ADDENDUM NO. 3

Date: **March 2, 2023**
Issued by: **Sacramento City Unified School District**
Project: **Project #0410-409 Albert Einstein MS Re-roof & Paint**

DATE: 02/15/2023
 JOB NO.: Y2243.00
 SHEET TITLE
EXTERIOR ELEVATIONS
 SHEET NO. **A715**

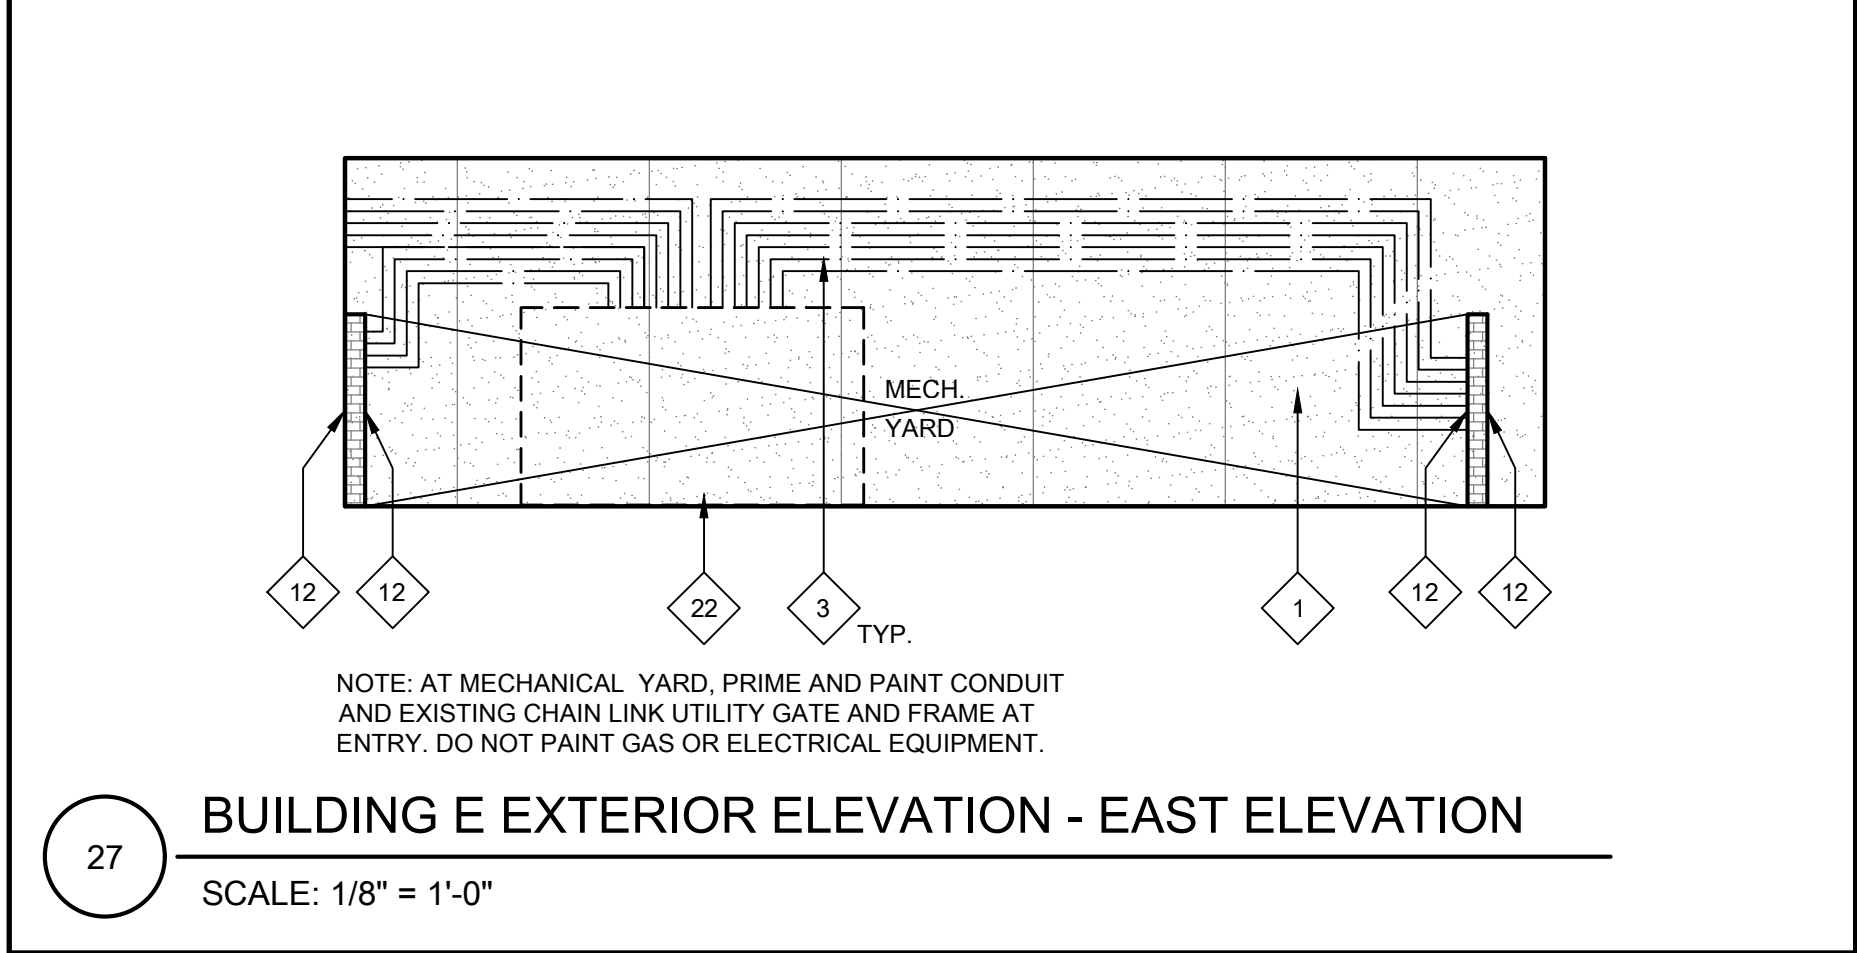
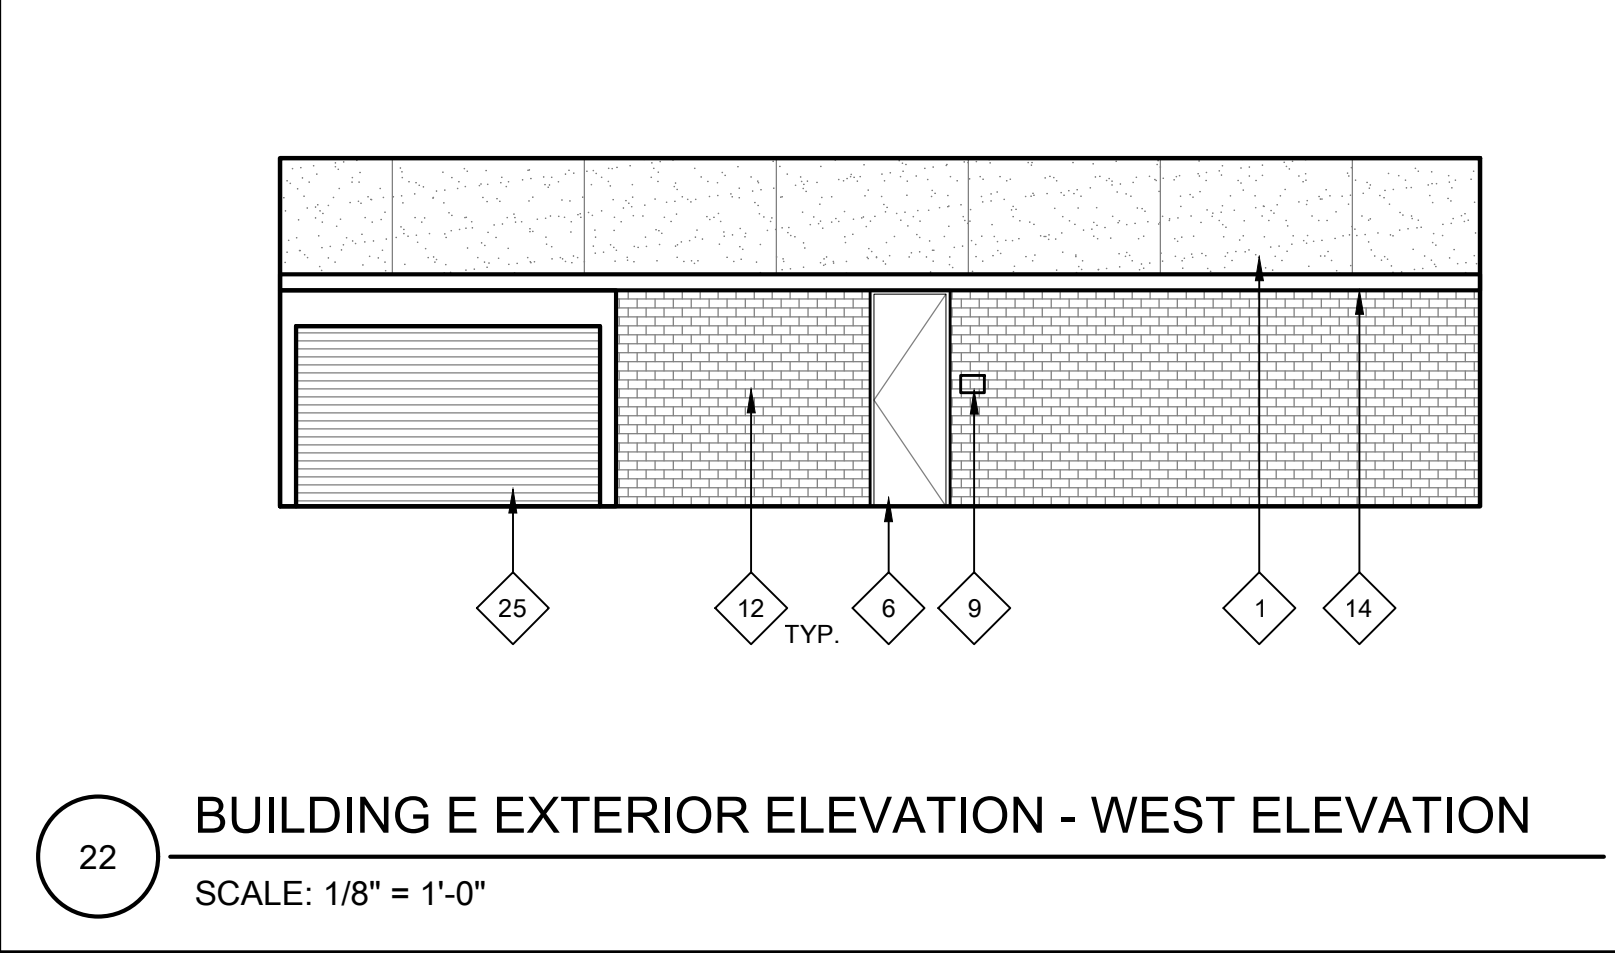
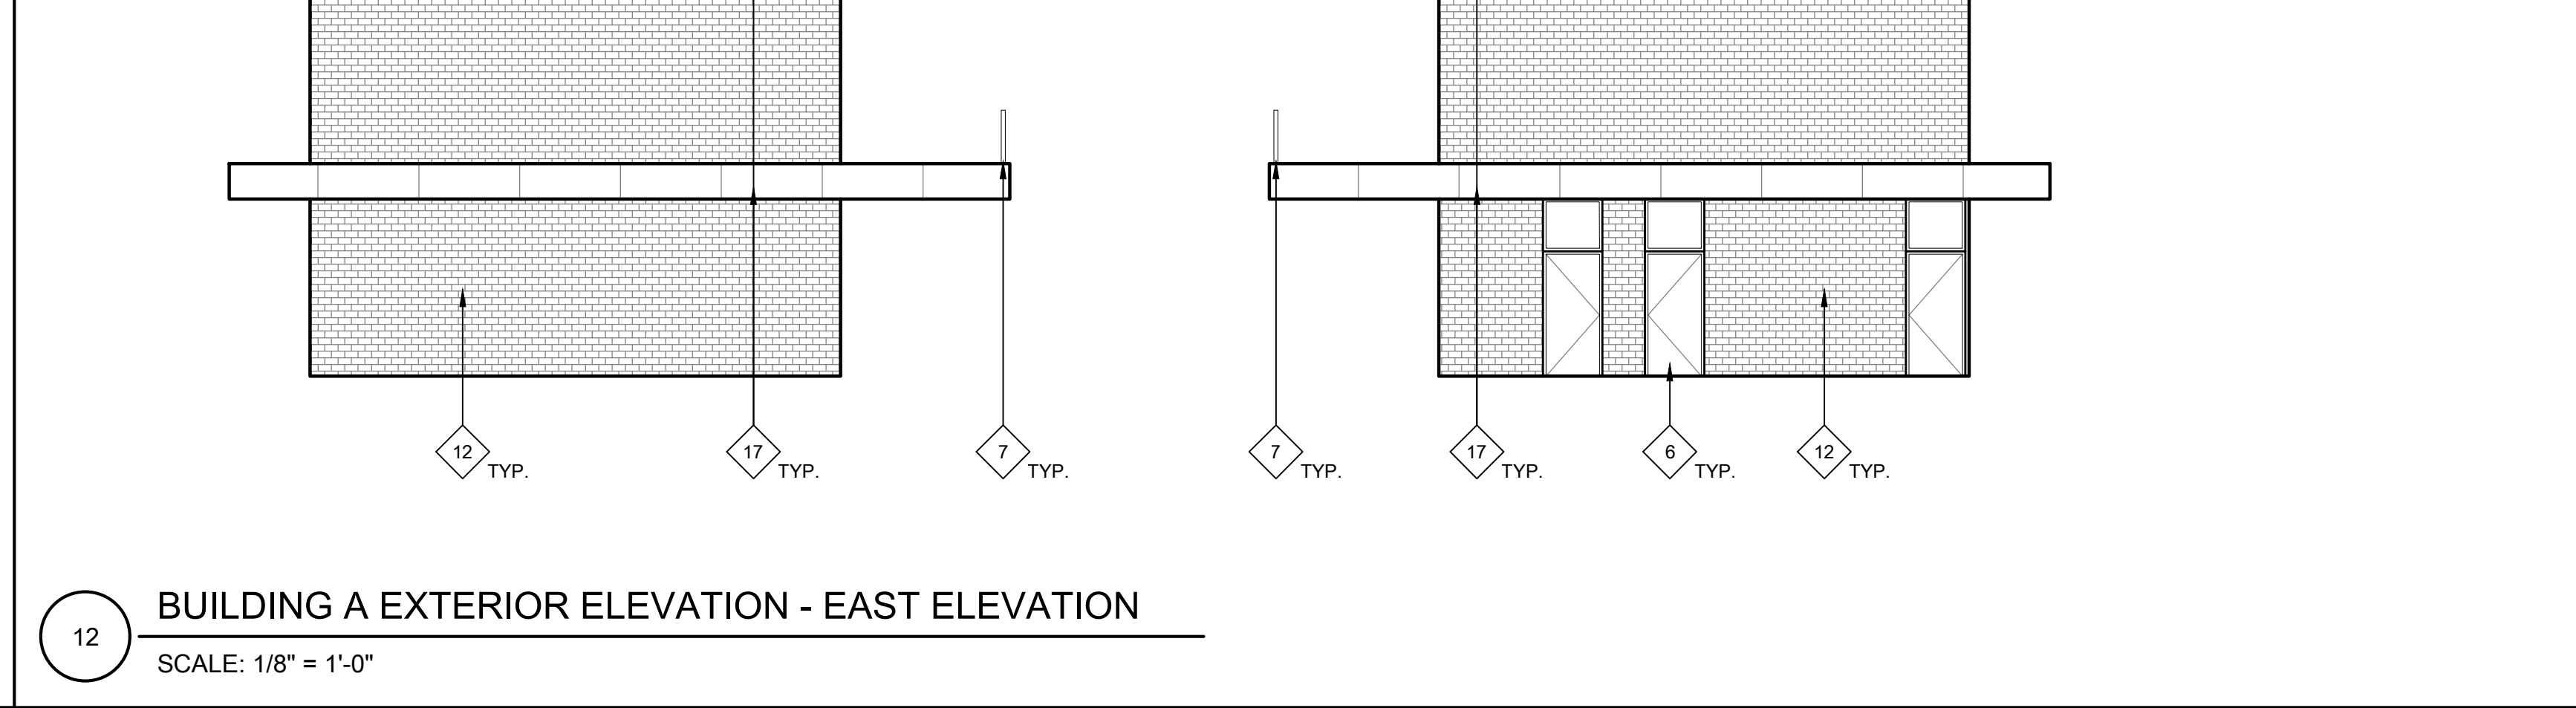
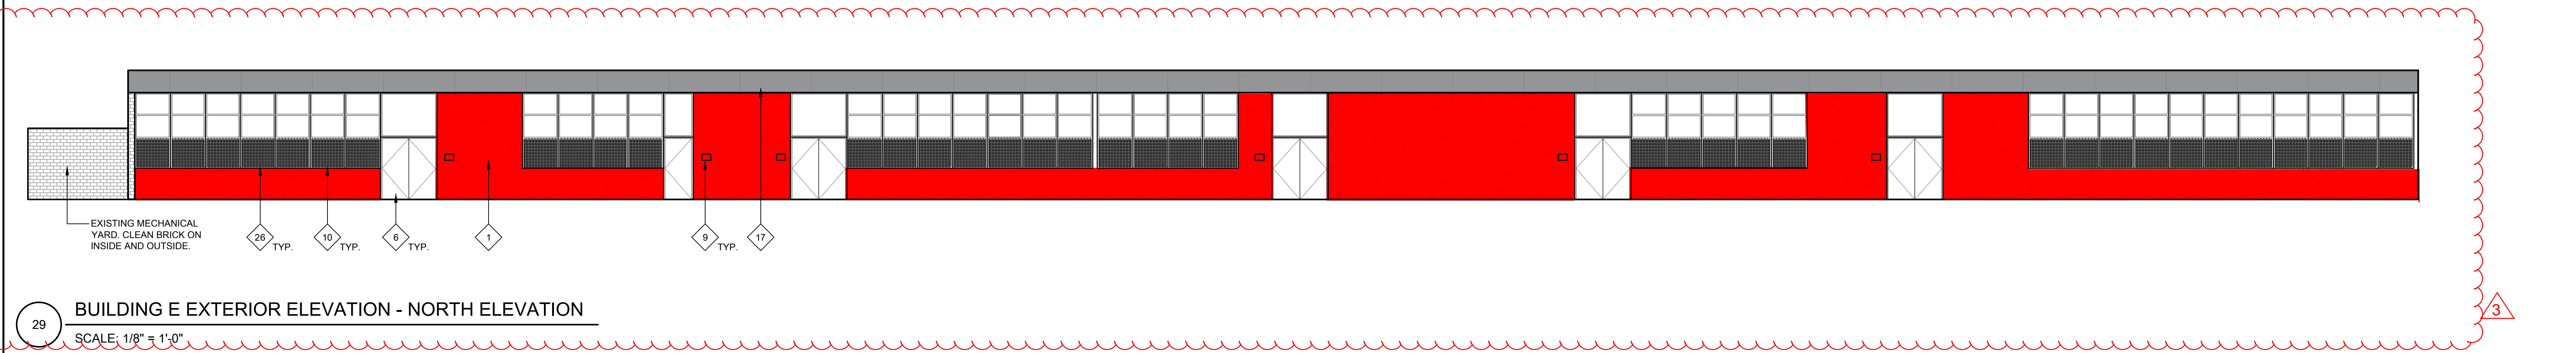
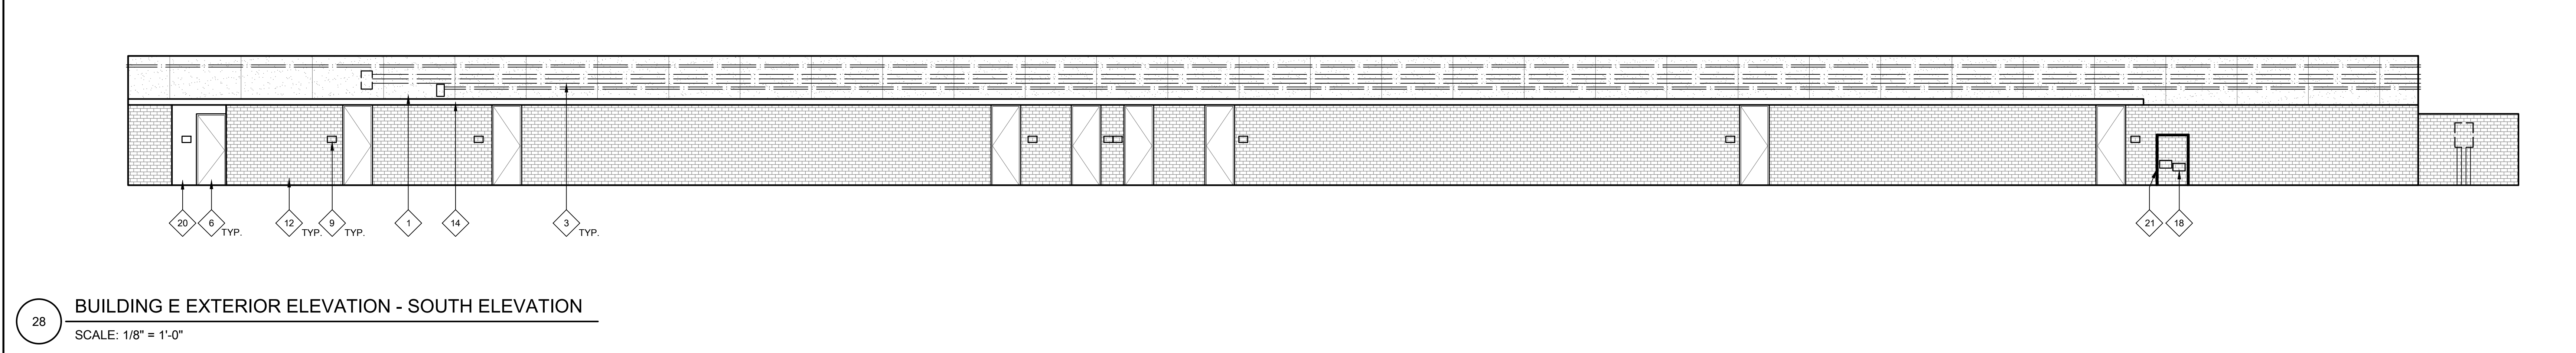
AD03.04 Sheet A715, Exterior Elevations, Building E: Revise wall prep at concrete walls to include media blasting down to bare concrete to remove flaking paint and provide "profile" on concrete wall surface. Prime and paint as described in Contract Documents. See attached sheet A715 with clouded areas.
